STATE OF HAWAII DEPARTMENT OF TRANSPORTATION HIGHWAYS DIVISION	
INDEX TO DRAWINGS	
RAMP-IF	
STA: 78+17.13 TO STA: 85+37.69	
AIRPORT INTERCHANGE	
F.A.I. PROJECT No. I-HI-1 (174)16	
SCALE: N.T.S.	DATE: SEPT. 1982
SHEET No. I-1 OF 42 SHEETS

Contract Change Order No. 2 - Footing 30F Revision

STATE OF HAWAII DEPARTMENT OF TRANSPORTATION HIGHWAYS DIVISION	
REVISED FOOTING 30F DETAIL	
RAMP IF	
AIRPORT INTERCHANGE E.A.I. PROJ. NO. I-HI-1 (174) 16	
SCALE: AS SHOWN	DATE: JULY, 1983
SHEET NO. 8A OF SHEETS

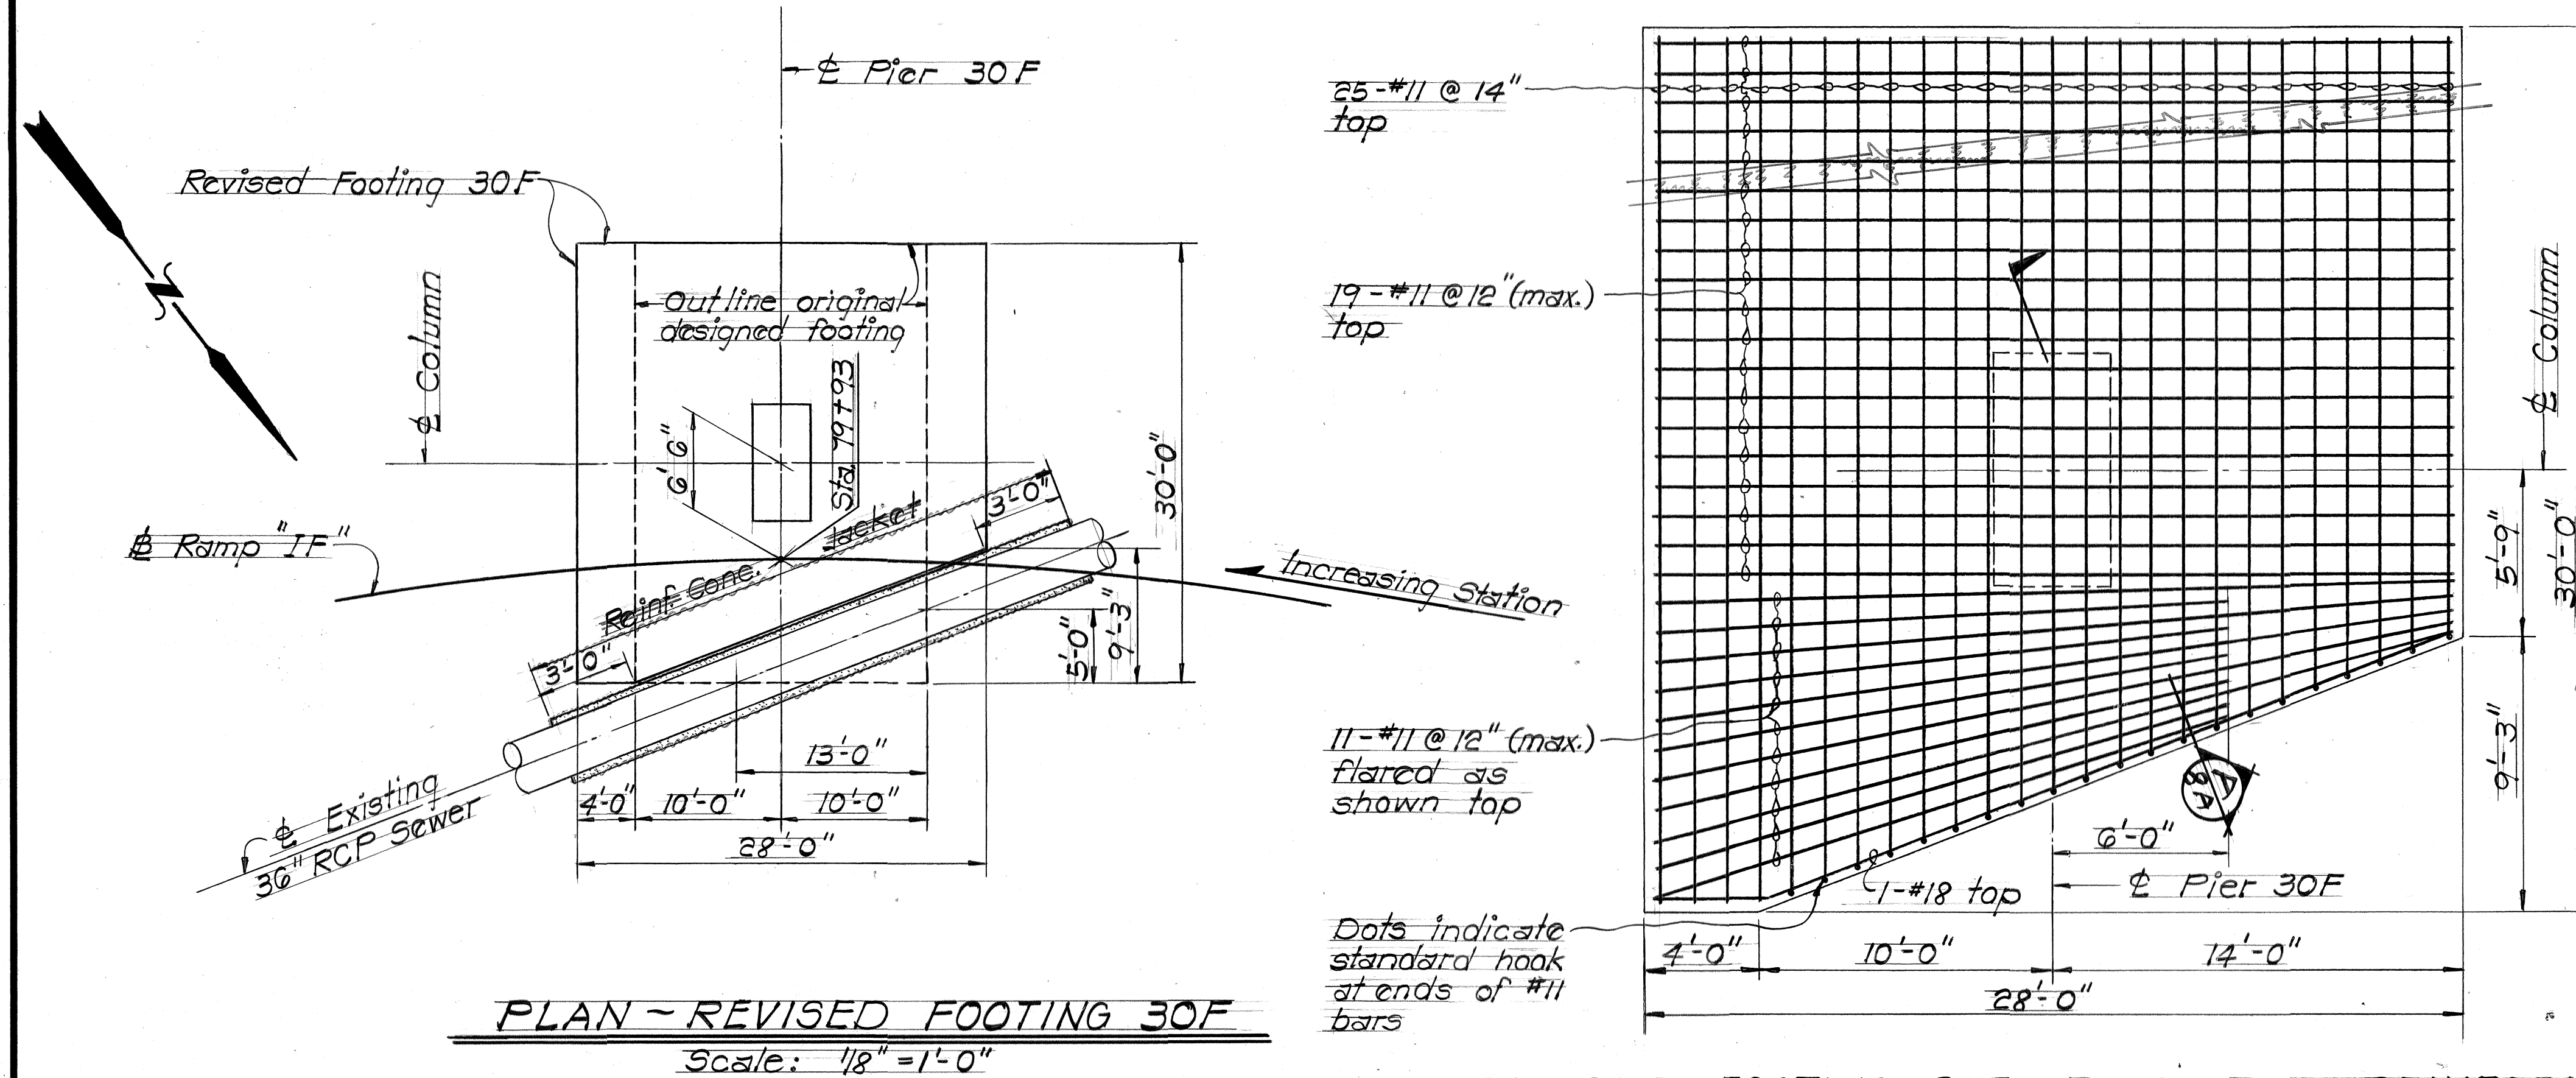
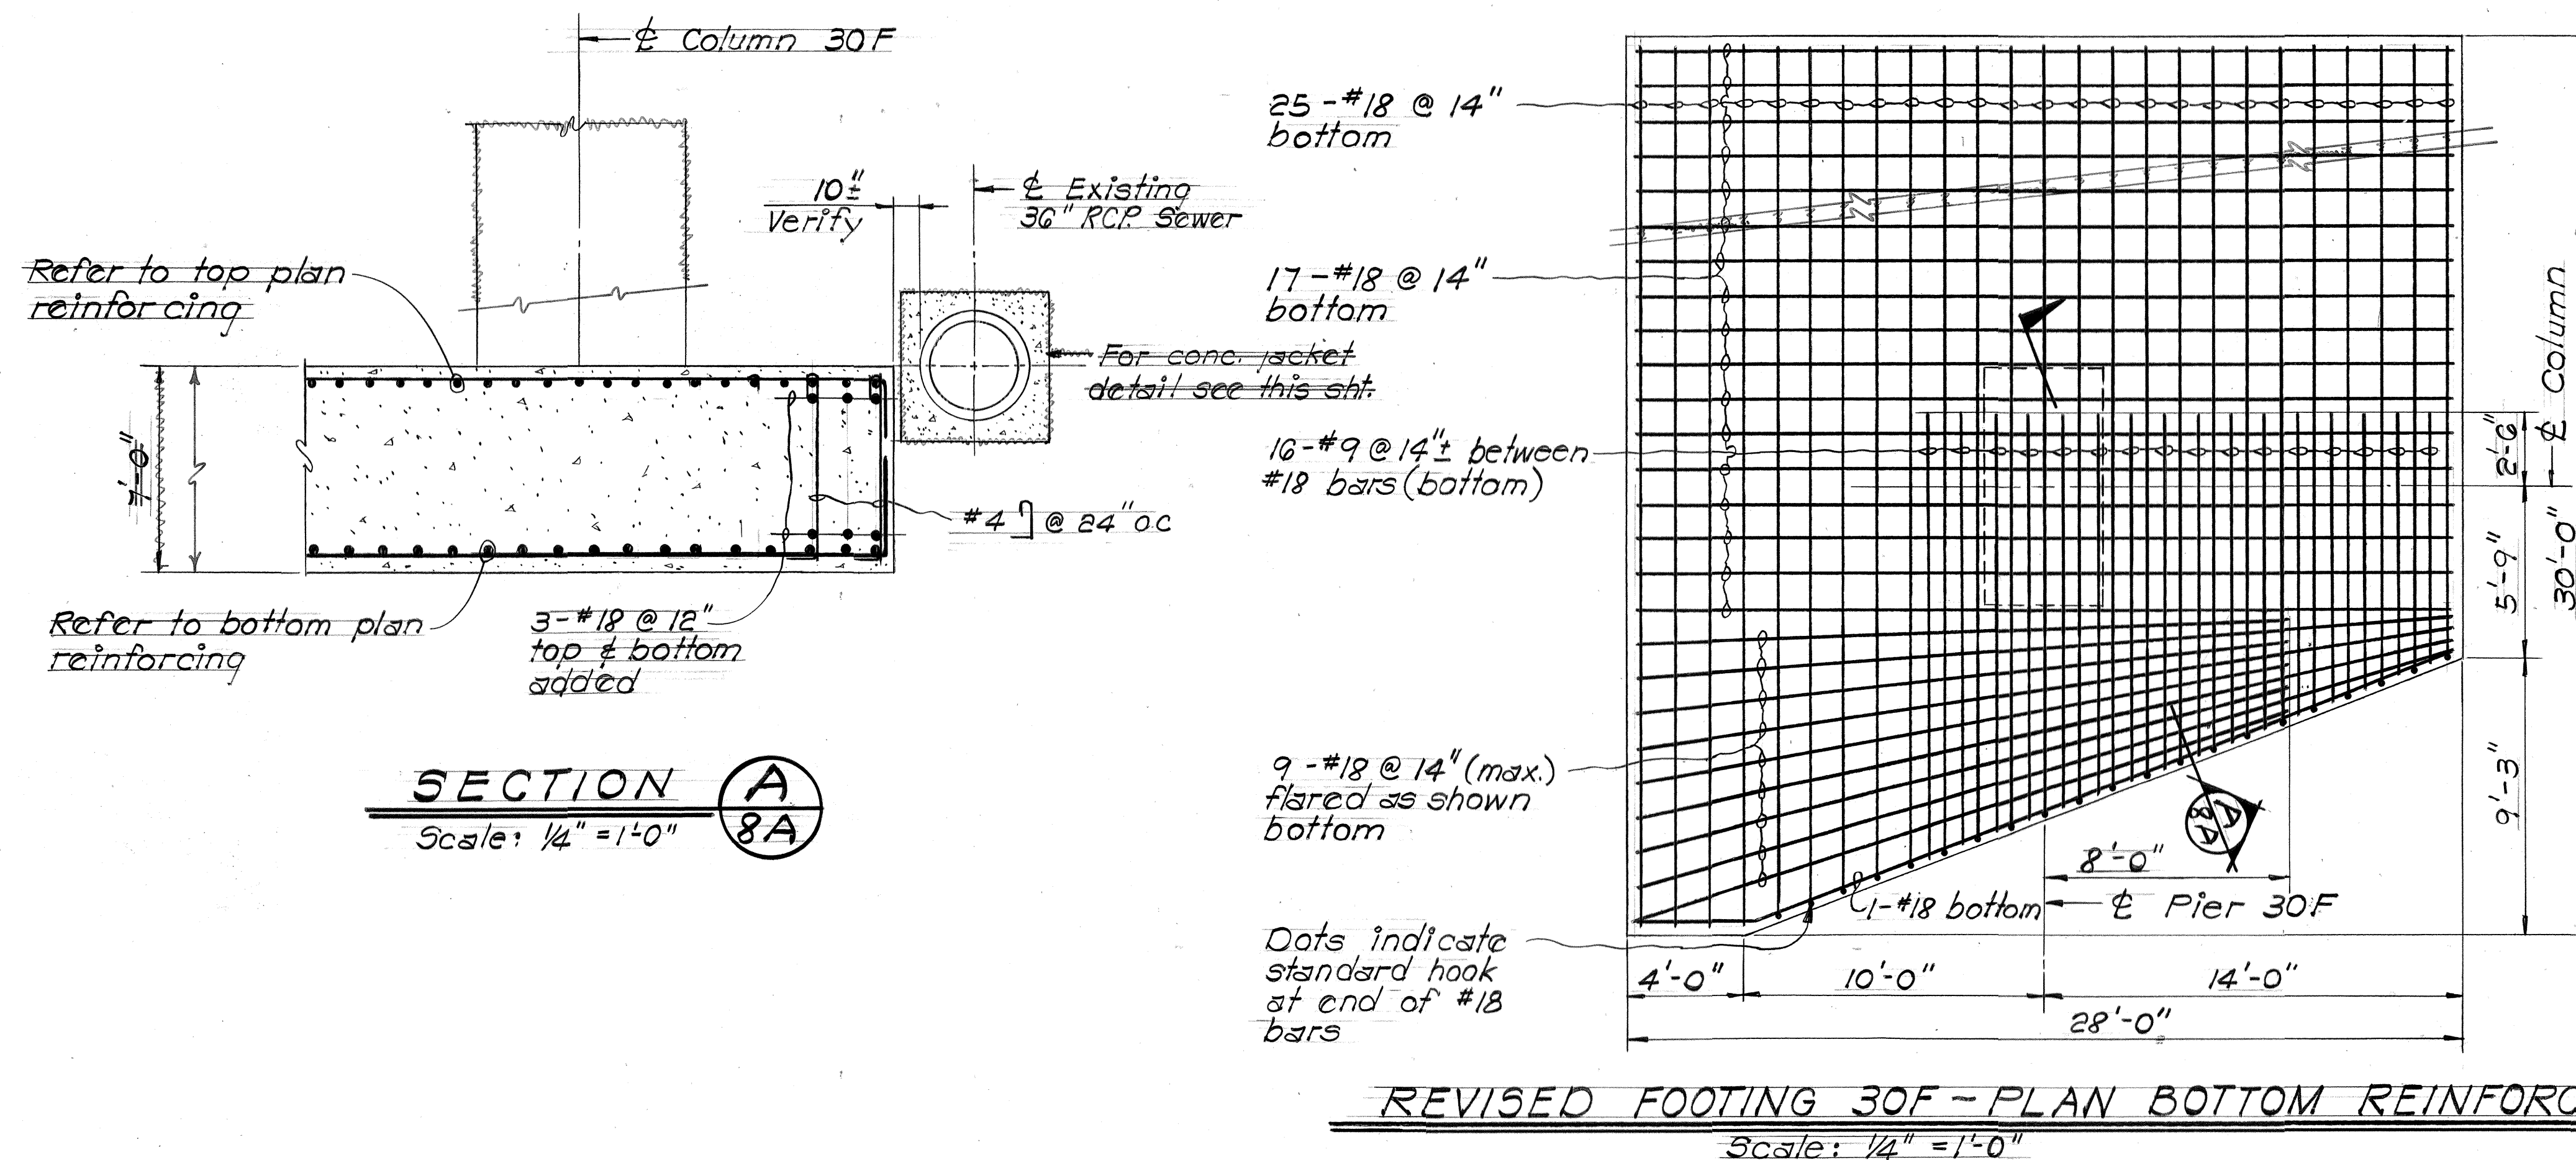
REVISED FOOTING 30F - PLAN TOP REINFORCING
Scale: 1/4" = 1'-0"

REVISED FOOTING 30F - PLAN BOTTOM REINFORCING
Scale: 1/4" = 1'-0"

REINFORCED CONCRETE JACKET DETAIL FOR EXISTING 36" SEWER MAIN
Scale: 1/2" = 1'-0"
Contract Change Order No. 4
